CDM: Form for submission of requests for revisions of approved methodologies to the Methodologies Panel (version 01) <i>(To be used by project participants, through the DOE/AE, for requesting revisions of approved methodologies)</i>
Name of the entity (DOE) submitting this form	
Reference number and title of the approved methodologies	ACM0013 – Consolidated baseline and monitoring methodology for new grid connected fossil fuel fired power plants using a less GHG intensive technology
Title/Subject (give a short title or specify the subject of your submission, maximum 200 characters):	Amendment of the methodology to account for the vintage of data used
Attach proposed revised approved methodology (with revisions in track change mode):	<input checked="" type="checkbox"/> Yes, is attached.
Attach draft CDM-PDD example of project activity:	<input checked="" type="checkbox"/> Yes, is attached.
Date and signature for the DOE

Version 3 of ACM0013

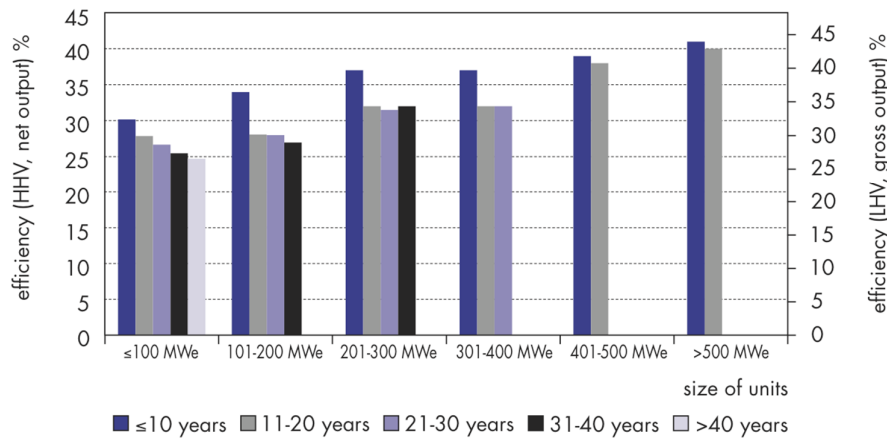
The overall effect of these provisions on the vintage of data used to establish the benchmark is illustrated in the following hypothetical example:

- Start of commercial operation of the CDM project: 2013
- Decision on the technology employed by the CDM project and request for registration: 2010
- Five-year period for which data is available: 2004 – 2008
- Start of commercial operation of plants used for the benchmark: 2004 – 2007
- Decision on the technology employed by the plants used for the benchmark: 2001 - 2004

This shows that the typical data vintage between the CDM project and the reference power plants used to establish the emissions benchmark is 6 to 9 years.

Average efficiencies of coal-fired power plants in China by age and unit size

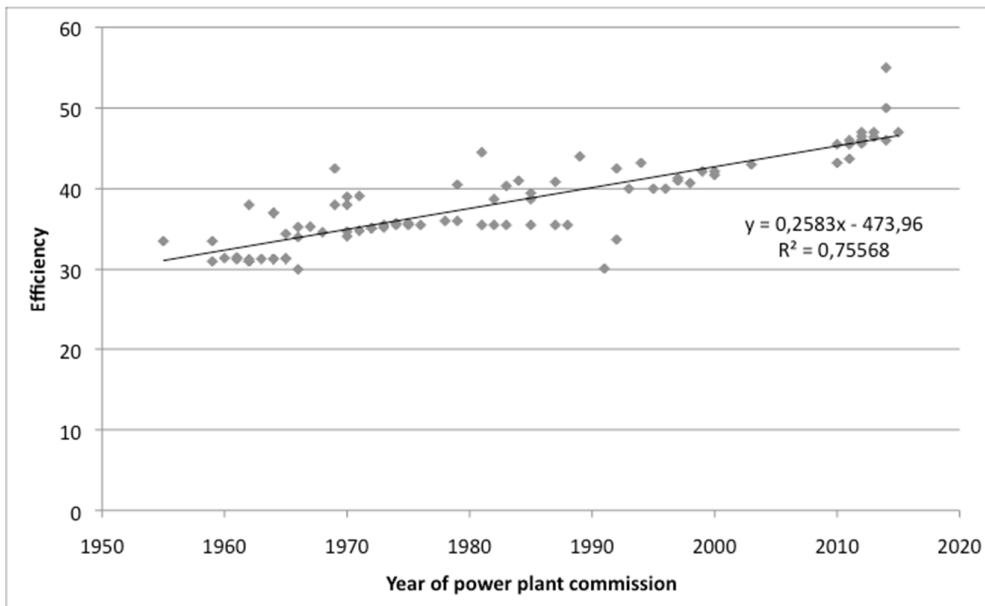
- The figure below from IEA (2008b, page 51) illustrates the efficiency improvements achieved in coal fired power plants in China. The figure shows that power plants between 100 and 400 MW, constructed in the last 10 years are 5-6% more efficient than power plants constructed in the ten years previously. This results in efficiency gains of 0.5% to 0.6% per year for power plants built in the most recent decade. The figure also shows that the improvements vary with the size of power plants and over time.
